CITY OF ALBUQUERQUE

Re: Los Altos Park Renovation – Phase I, K20D037

Based upon the information provided in your submittal received 09/01/2021, the Grading & Drainage Plans are not approved for Building Permit and Grading Permit. The following comments need to be addressed for approval of the above referenced project:

1st Flush Don
Vol. 7.

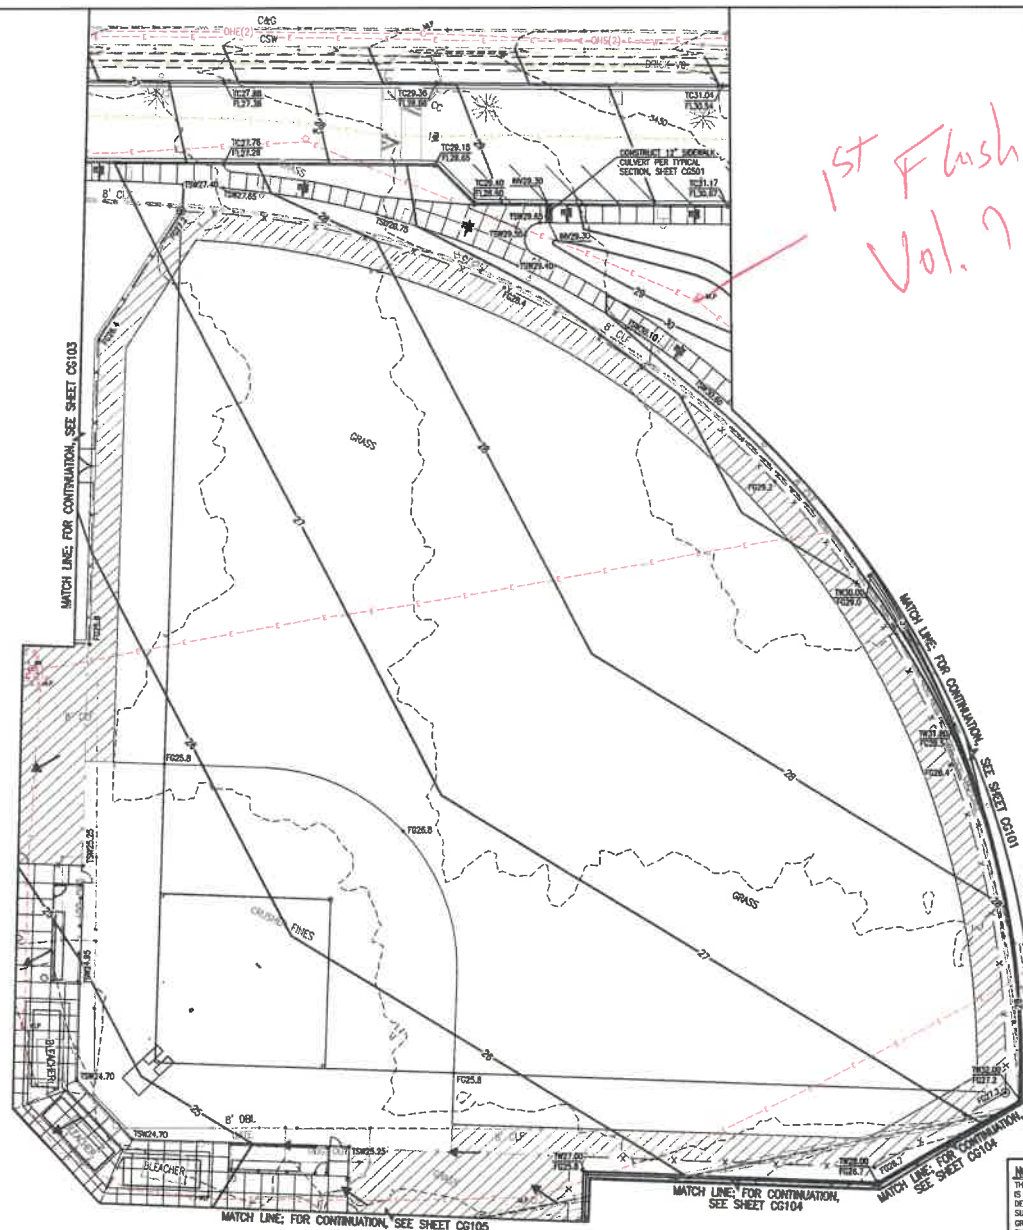
1. Provide an overall grading and drainage plan.
2. Clearly label 1st flush volume ponds including the volume for each ponding area. There appears more landscaping areas where can be used for 1st flush volume. See attached markup plans in red.
3. Provide calculations for inlets and storm drain pipes. A separate overall storm drain system plan would be helpful.
4. Under the drainage notes there is reference to a 48" RCP extending across Eubank. On Sheet CG111 calls out a 54" RCP.
5. Sheet CG501 was referenced for sidewalk culvert detail. Please provide details.
6. Provide details for the connections into NMDOT inlets. NMDOT approval and permitting will be required for the work within NMDOT's right-of-way.
